ARKANSAS POWER AND LIGHT  
ARKANSAS NUCLEAR ONE - UNIT 1  
CONTROL ROOM DESIGN REVIEW  
FINAL SUMMARY REPORT  
HUMAN ENGINEERING DISCREPANCIES  
VOLUME 2  
AUGUST 14, 1985

Category 1 HEDs

CORRECTIVE ACTIONS

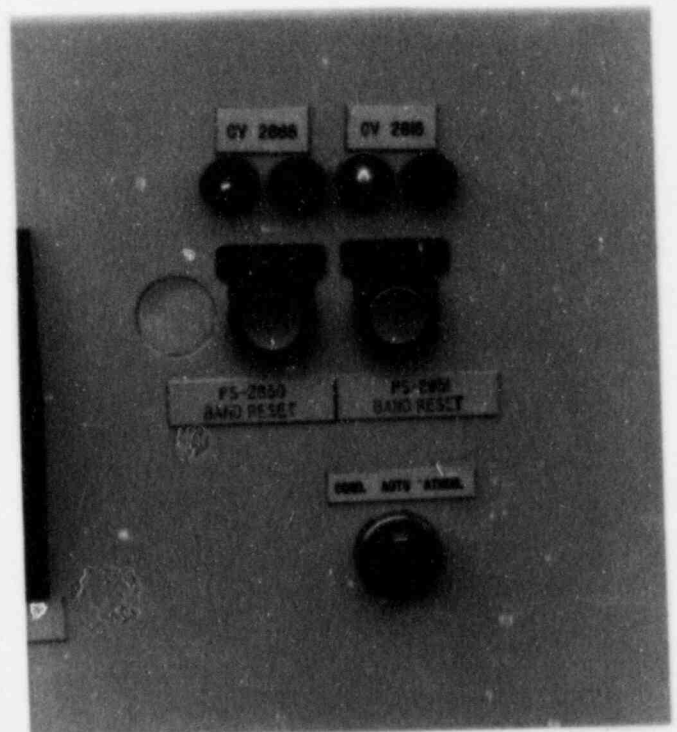
C02	Atmos Dump Isol
C02	PS-2850;2851;Band Reset
C02	Cond Auto Atmos Stm Dump Selector

The atmospheric dump isolation valves, CV-2676 and CV-2619, have been relocated to Panel C-09 during LR6 as part of AP&L's on-going commitment to the practical application of human factor's principles. The location on C-09 is appropriate since related controls are also on C-09.

The band reset and steam dump selector controls are to be evaluated for relocation on C-02 next to the associated controls on C-03.

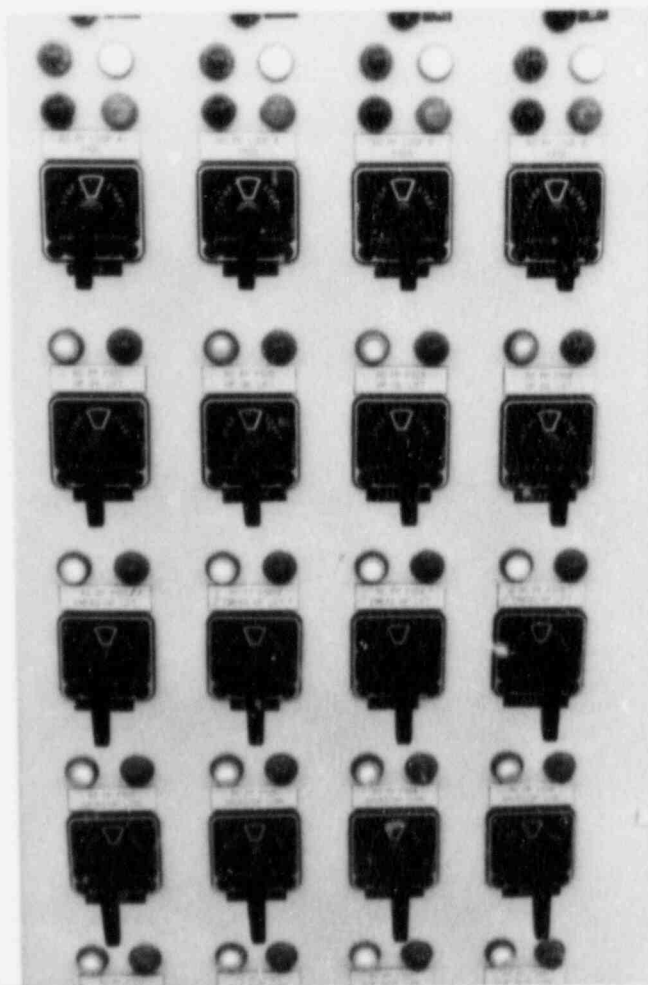
RCP pump controls and associated lube oil pumps are not arranged in logical alphabetical order.

The arrangement of the RCP controls will be evaluated for rearrangement and/or other identification enhancement techniques. (See CK:8-1.055 and VL:1-1.001).

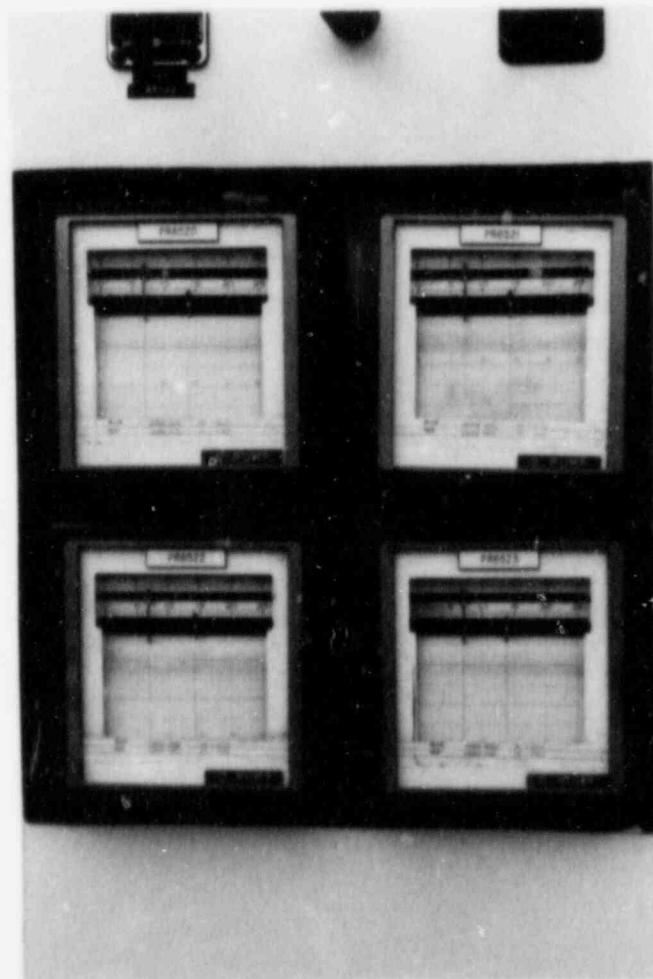
Recorders located out of visible portion of C-14 associated with operations at C-04. The recorders affected by this are equipment #'s PR6220, PR6221, PR6222, and PR6223.

The identified recorders will be evaluated for possible relocation to Panel C-13 from Panel C-14.

HED NO.: CK:4-1.005

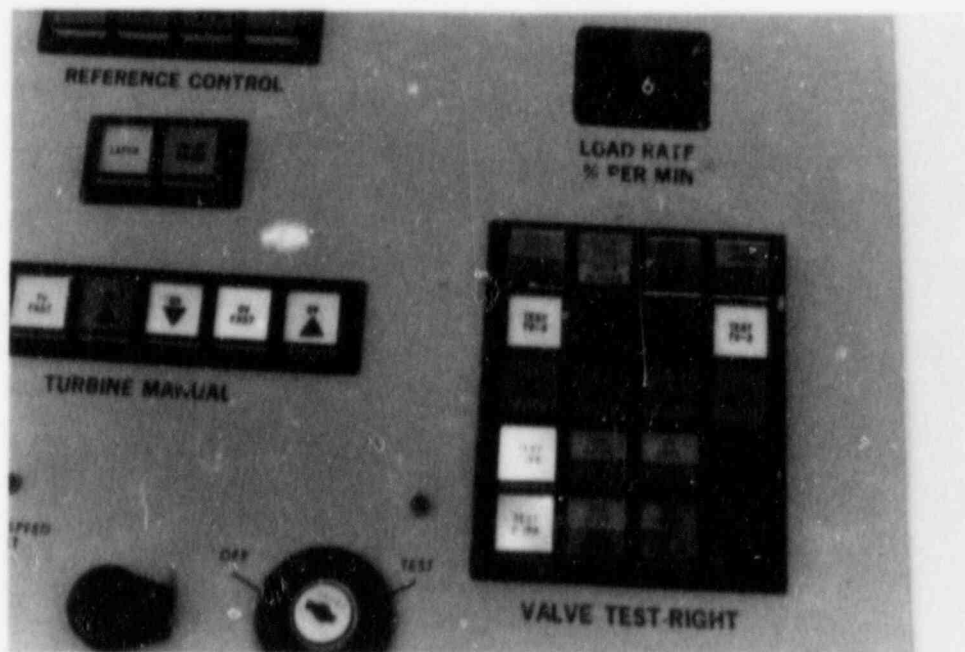
The legend is not readable under ambient light conditions (gray lights) on some pushbuttons and indicator lights on C01 when there is no internal illumination.

Although the contrast between the lettering and the pushbutton background is not high, the legends are readable under the existing control room lighting conditions. Therefore, no further action is planned to address this HED.

HED NO.: CK:5-1.005GUIDE NO.: 5.2.2b(2)RATING: 3FINDING:

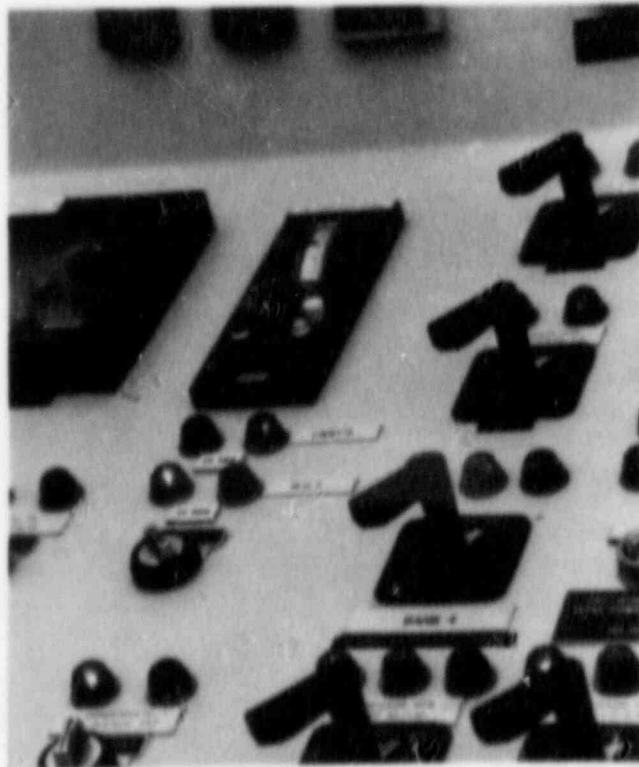
Some displays are mounted to the rear of the benchboard requiring operators to lean to avoid parallax. The following displays are affected: Panel C-04; Equipment ID# LI1604, PI1608, CV1207, CV1235, PIC1004.

HED NO.: CK:5-1.020GUIDE NO.: 5.1.5a(1)RATING: 3FINDING:

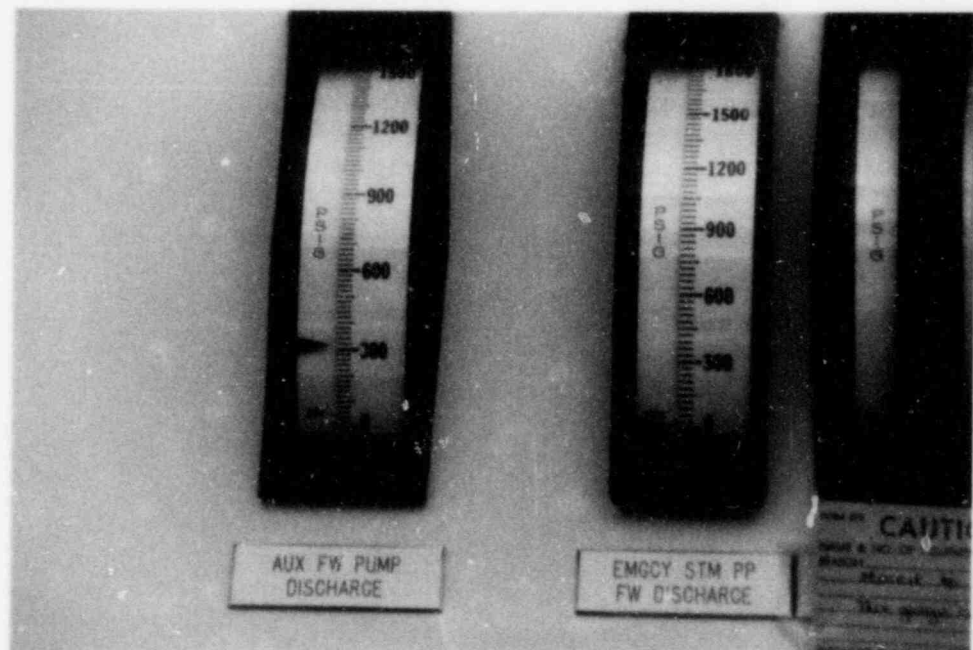
More than 9 graduations separate numerals on some displays. The following displays are affected; Panel LO9:#PI3606, PI3607, PI3608; Panel C12: Aux FW Pump Discharge; Panel C16/C14: PI1050, PI1410, Emergency Injection Loop B1/B2, Core Flood Tank Level A2/B2, FI2620B, FI2670B; Panel C19; instrument air header, Gen L.O. CLRS Aux Circ Wtr, Gen H2 CLRS Aux Circ Wtr, Panel C01: U EXC FLD; Panel C02: Turb K2A Steam In, Turb K2B Steam In.

The referenced instruments all have compatible log scales. Prior to 1R6, linear scales existed on some instruments that were not operational. During 1R6, the correct log displays were installed and the instruments were made operational. Therefore, the comparable displays have the same scales (i.e., log scales) such that this HED has been corrected.

HED NO.: CK:5-1.024GUIDE NO.: 5.1.5a(3)RATING: 3FINDING:

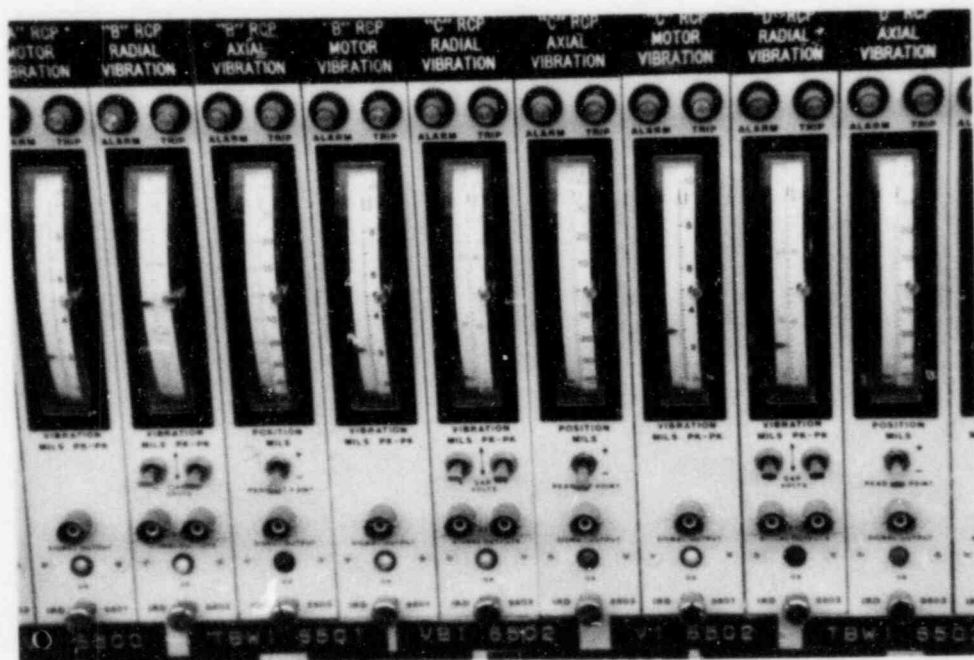
Three thicknesses of graduations (major, intermediate, and minor) are not used for some displays which contain five or more graduations between numerals. The following displays are affected:

HED NO.: CK:5-1.030GUIDE NO.: 5.1.5f+5.4.2a(1)RATING: 3FINDING:

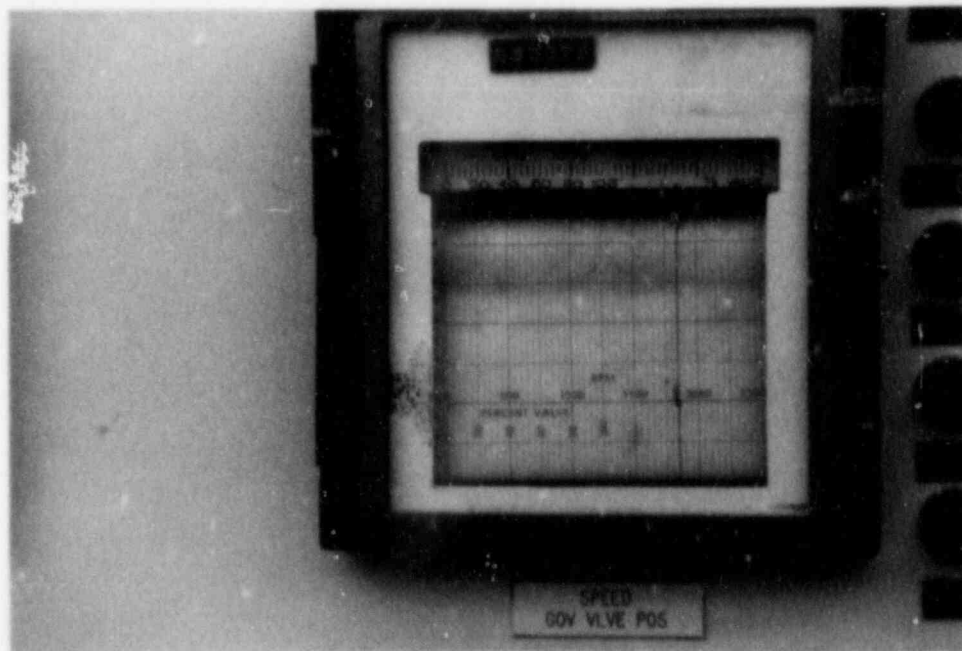
There are two scales on the Speed Gov Valve Position recorder. The operator determines which scale is activated (being used) by controls on back panels. There is no control room indication of which scale is being used.

HED NO.: CK:5-1.033GUIDE NO.: 5.2.1bRATING: 3FINDING:

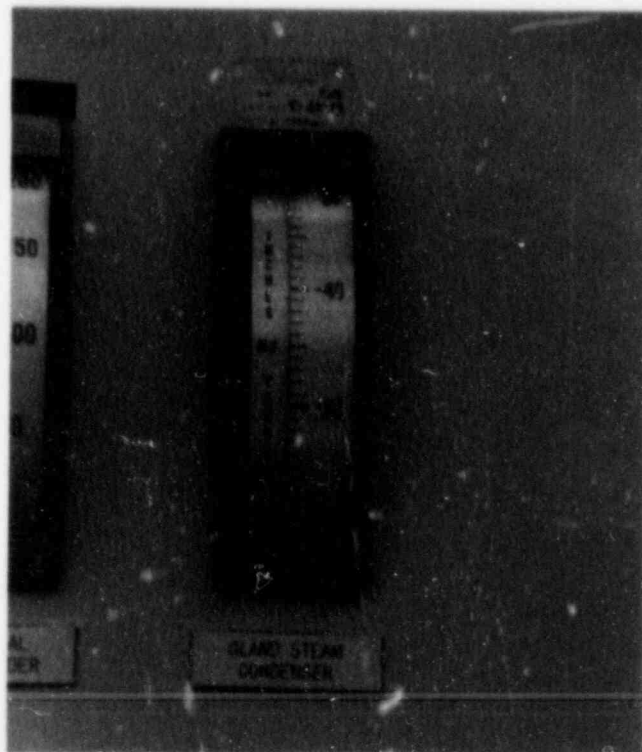
The scale values for three displays do not increase with upward movement of the pointer. The following displays are affected: Panel C12: Gland Steam Condenser; Panel C13: TDI1033; Panel C19: LI2004.

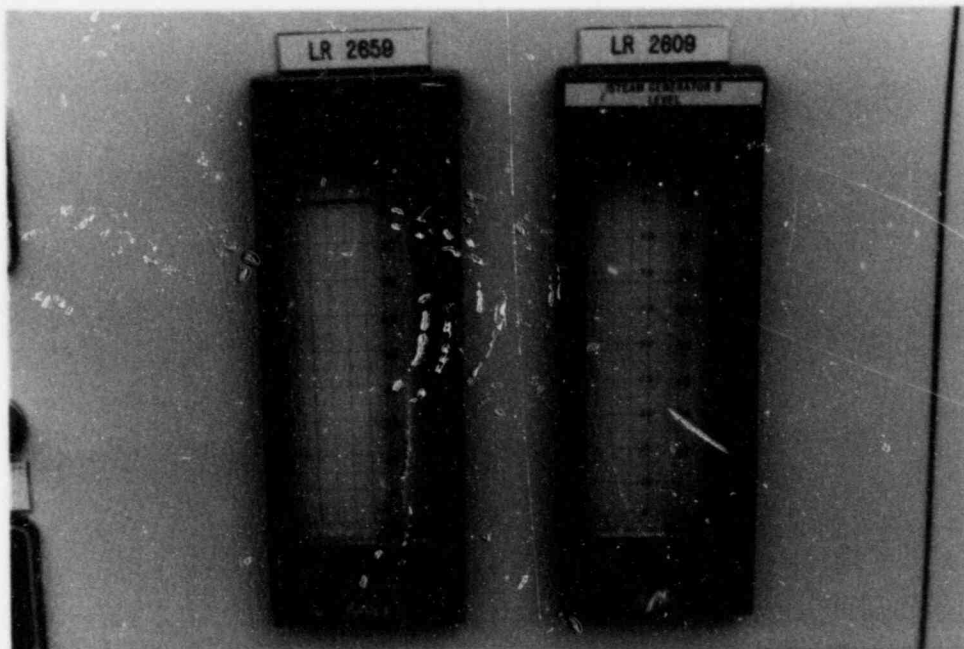
Equipment ID#	Equipment Name
TR 6612	Temperatures FW PPS Turbs
LR 2609	Steam Generator B Level
LR 2659	
FR 1032	Reactor Coolant Total Flow
TR 1024	Reactor Ave Temp
TR 1023	Reactor Outlet Temp
PR 6520	A Pump
PR 6521	B Pump
PR 6522	C Pump
PR 6523	D Pump
PR 2408	Reactor Bldg Pressure
	Trend Recorder 1
	Trend Recorder 2
	Trend Recorder 3
	Trend Recorder 4
	Trend Recorder 5
FR 2632	Feedwater Flow/Loop A
FR 2682	Feedwater Flow/Loop B
PR 2634	Turbine Throttle Pressure
	Intermediate Range
	Power Range 0
LR 2871	Condenser Level
PR 2412	RX Bld Press
LR 5645	RX Bld Level

The parameters recorded for the identified recorders will be or have been corrected as follows:

The recorders on C-16/C-18 (PR-6520, PR-6521, PR-6522 & PR-6523) have been replaced with new recorders during 1R6 that have the parameters identified by labeling. The recorders on C-100 (trend recorders 1 thru 5) do not have the parameters permanently labeled since these recorders are available for

HED NO.: CK:5-1.047GUIDE NO.: 5.5.1c(1)RATING: 3FINDING:

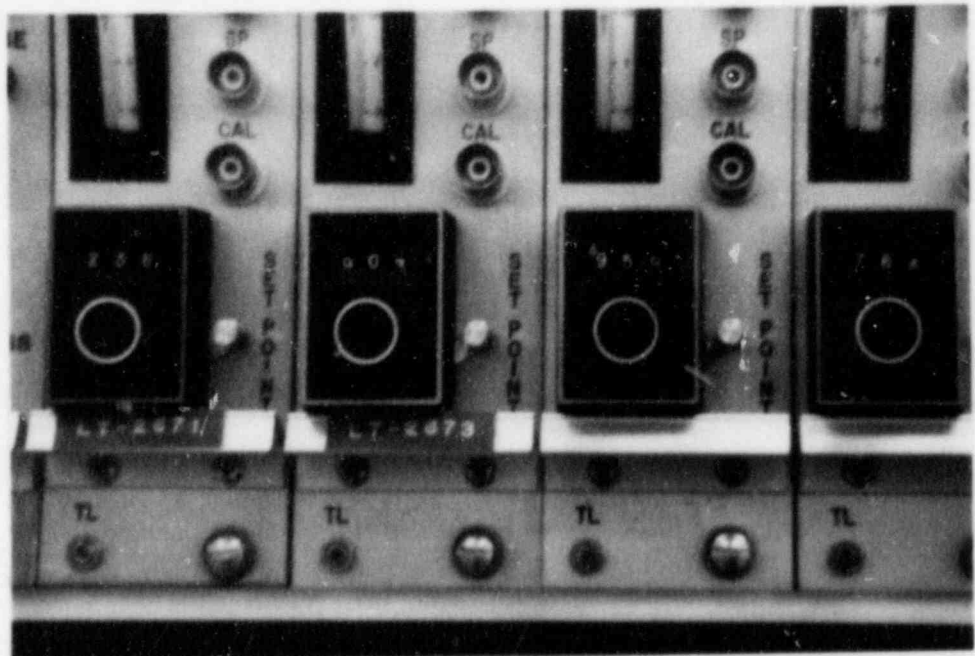
The numbers on drum counters change by continuous movement rather than by snap action. The following displays are affected: Panel 37-1, 37-2, 37-3, 37-4: all drum counters.

HED NO.: CK:8-1.030GUIDE NO.: 8.2.2.aRATING: 3FINDING:

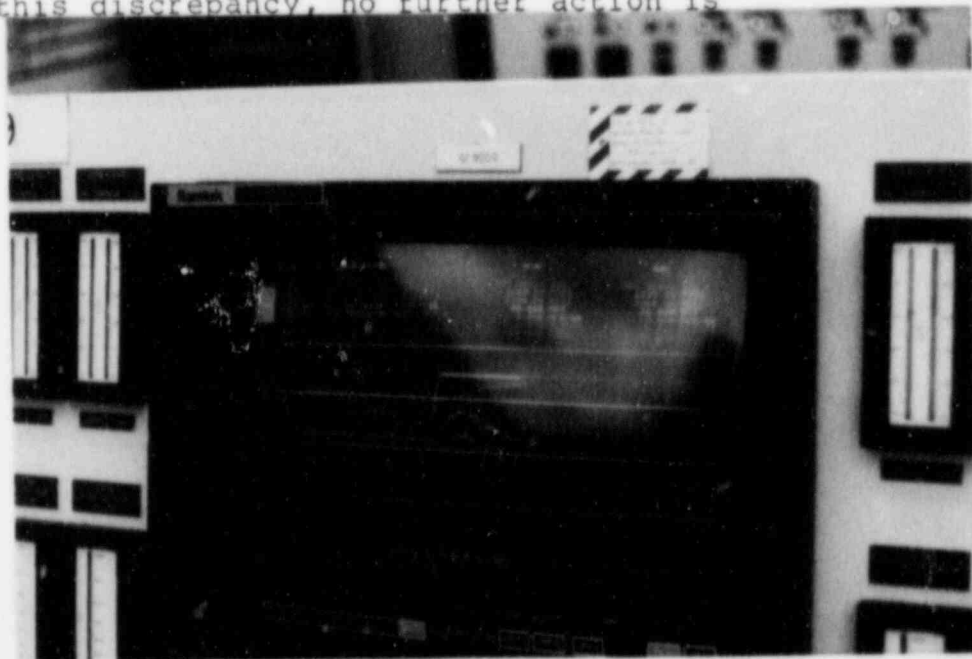
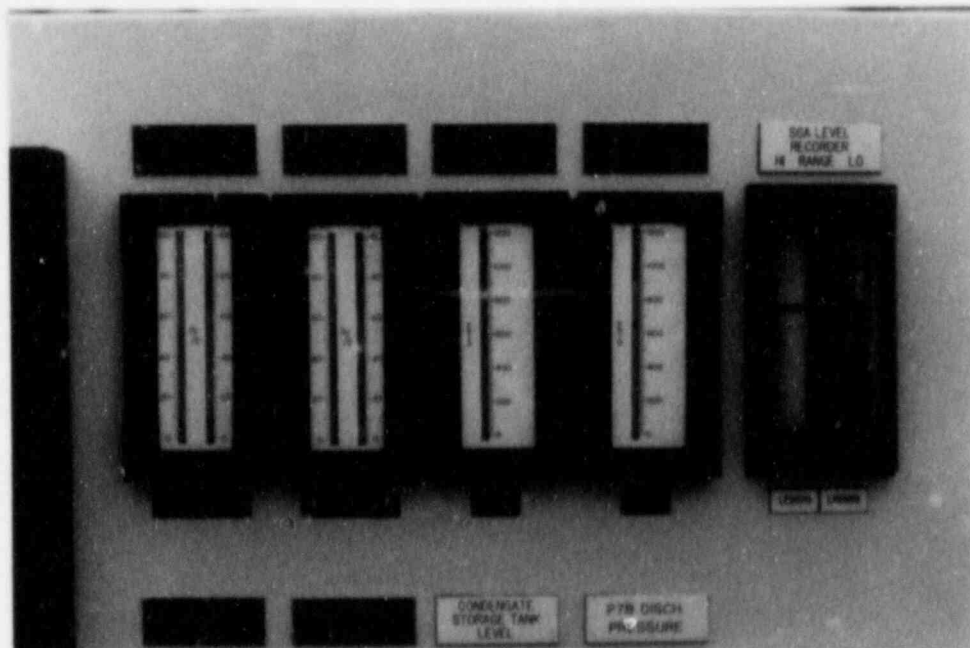
SGB indications on left of SGA indications violating left to right alphabetic ordering.

SG A&B indications are mirror imaged for SGA; level; level; pressure; pressure for SGB; pressure; pressure; level; level.

The use of mirror imaging on panel C-09 was done to make the comparison of indicators easier when standing in front of the SPDS display. The operator uses the SPDS display as a center point and reads outward to his left and right to get information on the steam generators and EFW pumps. This arrangement is considered beneficial by the plant operators. Therefore, due to a lack of justification for change, no further action is planned to address this HED.

HED NO.: CK:8-1.032GUIDE NO.: 8.3.1.aRATING: 3FINDING:

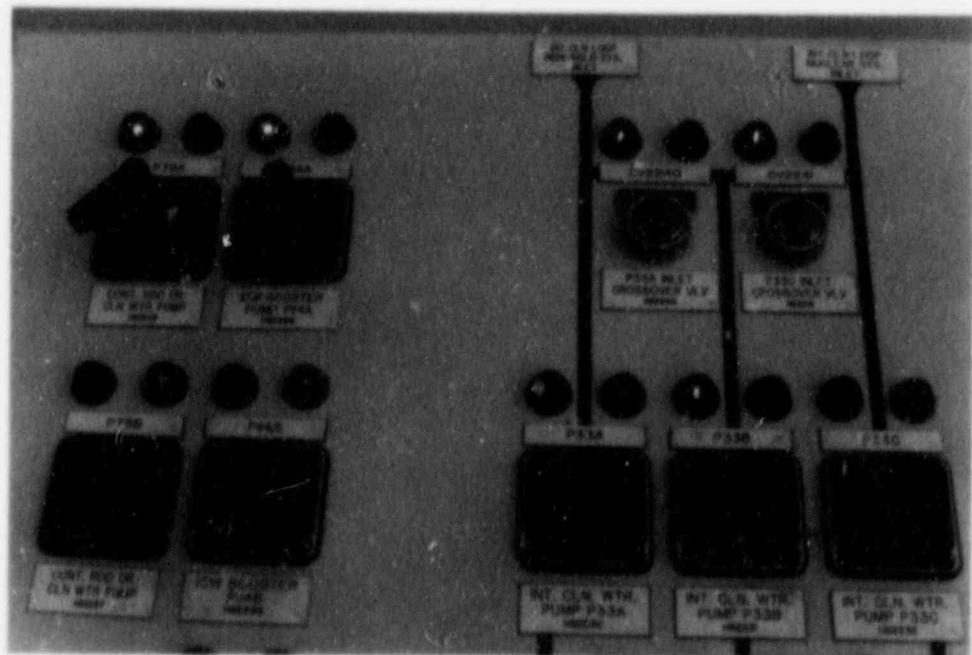
J-handles violate minimum distance separation. P79A and P79B are not spring return and may hinder operation of P114A and P114B. P33A; P33B; P33C are spring return and should be OK as long as simultaneous operation is not required.

HED NO.: CK:8-1.053GUIDE NO.: 8.1.2.bRATING: 3FINDING:

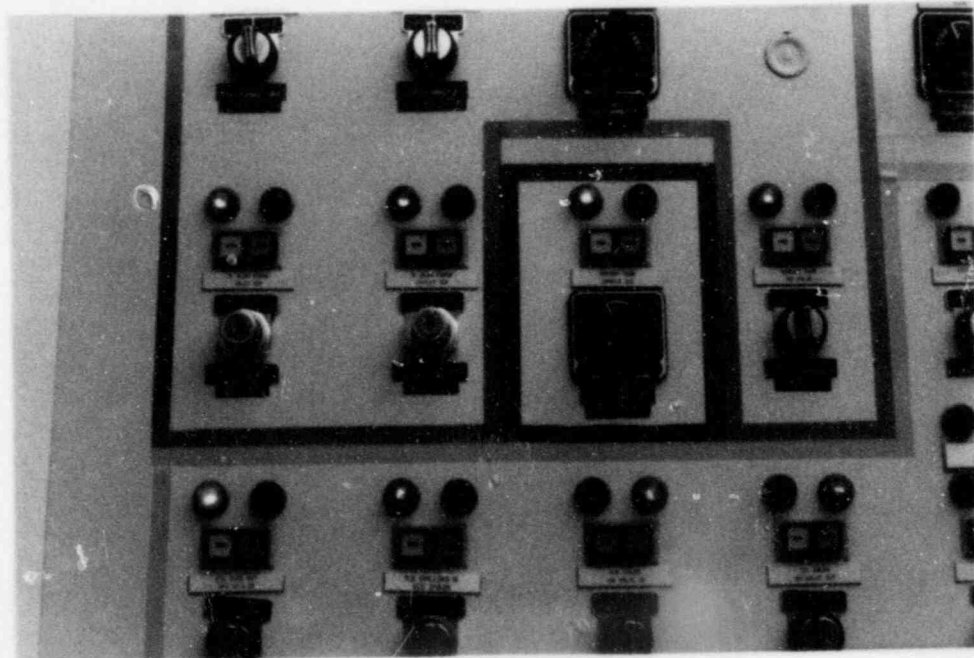
Components not appropriately demarcated according to convention. Component labels indicate different channel from demarcation grouping labels. Panel C18/C16. The affected components are as follows:

HED NO.: CK:8-1.057GUIDE NO.: 8.2.3aRATING: 3FINDING:

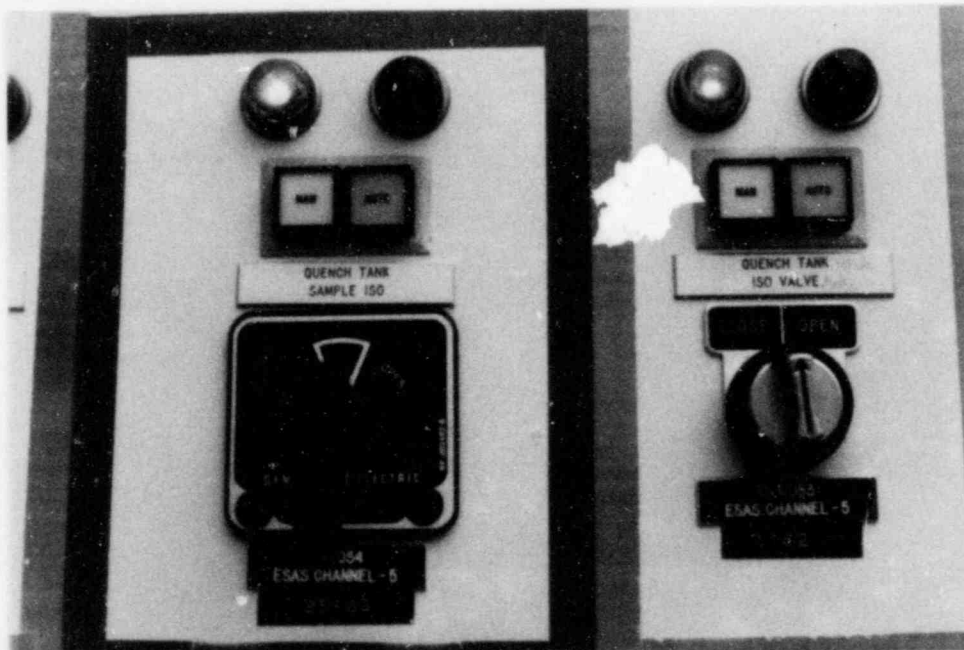
Components within an ESAS channel grouping are not arranged in the same manner as those within the duplicate ES channel grouping on Panel C-16 and C-18. The affected components are as follows:
